## SUBMISSION TO TfNSW - PROPOSED BULLI AND THIRROUL TRAFFIC MANAGEMENT OPTIONS

## **Bulli & Thirroul Traffic Improvements Project – Wollongong City Council Submission**

Thirroul Preferred Proposal

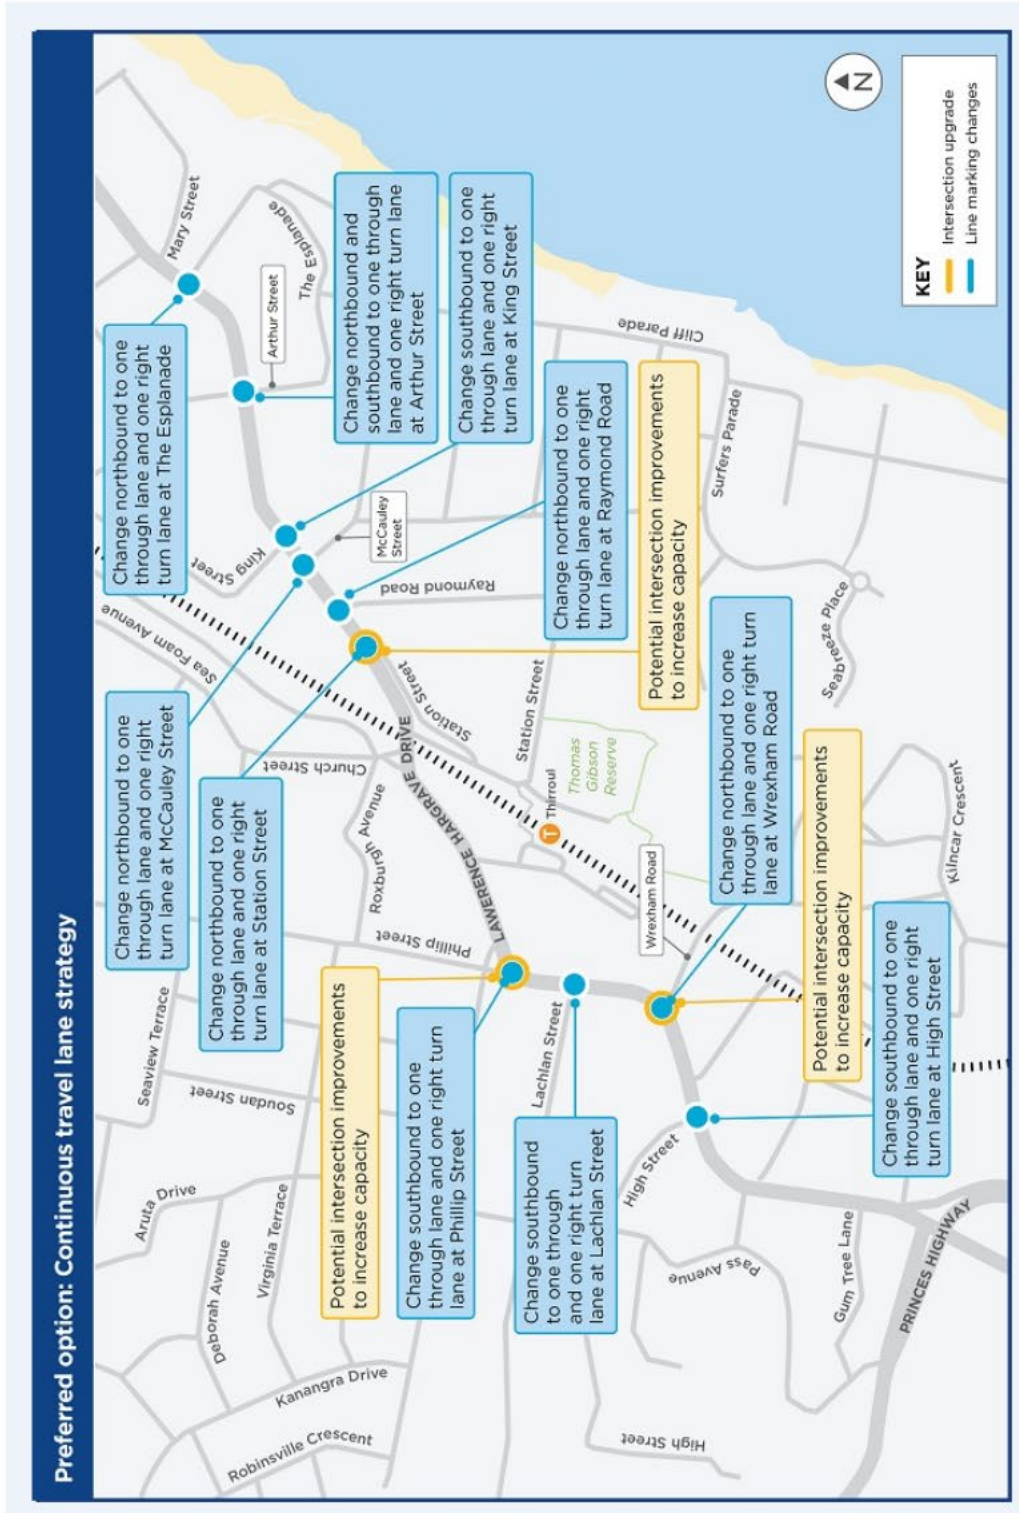
- This proposal reduces the number of formal crossing points for pedestrians.
- Informal crossings likely to occur on proposed chevroned areas which may be unsafe for pedestrians given continuous high flow traffic lane proposed. It will be difficult for pedestrians to find adequate gaps in traffic.

- No facilities are proposed for cyclists.
- There may be opportunities to provide refuge crossings at various locations for pedestrians that are currently shown as painted medians. These crossing facilities are particularly important if parking is being removed along the LHD and visitors need to park in side streets.

- It is unclear why the existing pedestrian refuge north of King St needs to be impacted – there appears to be some space to run the northbound lane further west as it currently does to accommodate the central refuge island.

- Information lacking on proposed bus route adjustment where lane goes through existing bus stops (may result in reduction in public transport servicing/accessibility)

- This option affects pedestrian amenity where parking lanes are replaced by travel lanes. Car parking provides a buffer between moving vehicles and footpaths. Removal of this parking will make pedestrians feel less safe on the footpath and will generally make the footpaths less attractive for pedestrian use. The removal of the buffer will also impact amenity and the comfort of pedestrians who frequent these businesses which is an important factor for 'place'.

- The car parking losses are shown in the consultation material as being 5 spaces on LHD between Phillip St and Railway Pde. However, in the modelling report, the preferred option was selected based on the 'Layout 2' upgrade of Phillip St/LHD intersection that required the permanent loss of 8 car parking spaces on the west side of the road (refer Fig 5.8 of report). There is an inconsistency here – does the planned upgrade still require the loss of the 8 spaces on the west side of the road?

- How have the lengths of the right turn bays been developed? The modelling report identifies the right turn pockets of between 30-50m length but there is no evidence of whether these lengths are appropriate as provided. It is assumed they were observed to perform adequately through Aimsun, however more detailed intersection modelling may indicate different requirements. There is a risk that any required lengthening would further impact kerbside parking and business viability.

Thirroul Alternative Proposal

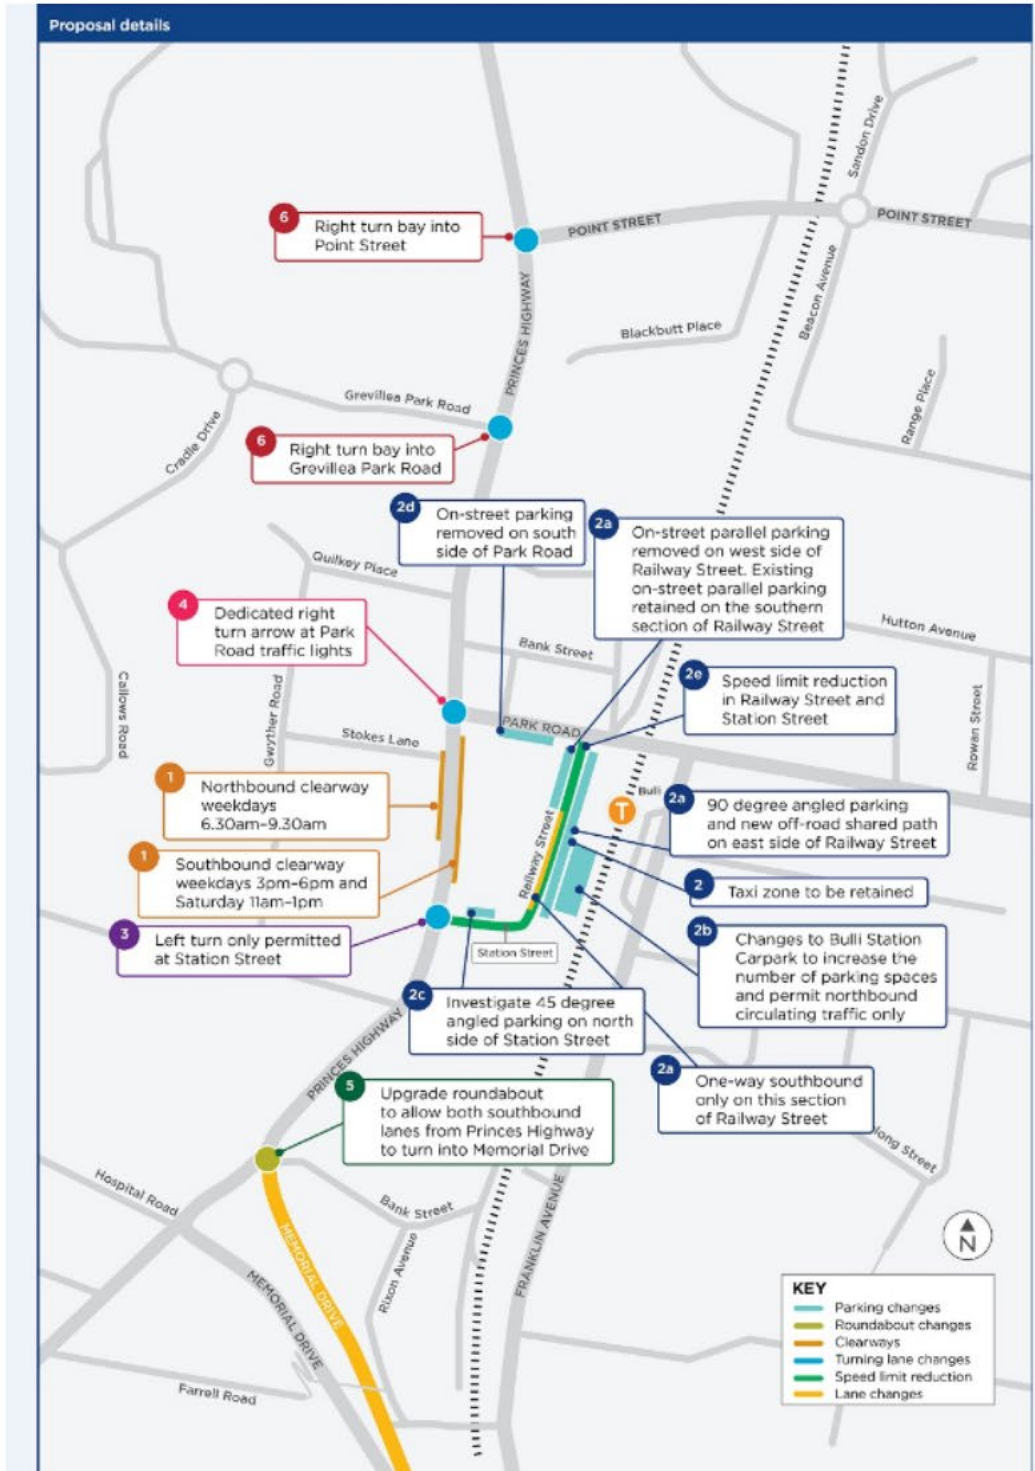
- The travel time reductions table provided showed a significant time reduction for Thirroul on Saturdays without the inclusion of clearways. This suggests that the same treatments without clearways could provide benefits. Modelling scenarios should be assessed that quantify benefits of applying the clearways during weekday peaks.
- Information is needed on why kerbside parking was removed permanently (not just clearway) in central Thirroul. These parking space removals will significantly affect business viability. Peak period modelling would not have assessed benefits of this change outside of peak times.
- How were the proposed clearway hours determined? The model only considers the peak hour, but what is being proposed is for a longer period – are the nominated periods based on traffic count profiles?

- A significant pedestrian safety hazard is introduced with the multilane modification of the Hewitts Avenue roundabout. Pedestrians crossing LHD will need to cross two lanes of high flow traffic.
- This option affects pedestrian amenity where parking lanes are replaced by travel lanes. Car parking provides a buffer between moving vehicles and footpaths. Removal of this parking will make pedestrians feel less safe on the footpath and will generally make the footpaths less attractive for pedestrian use.
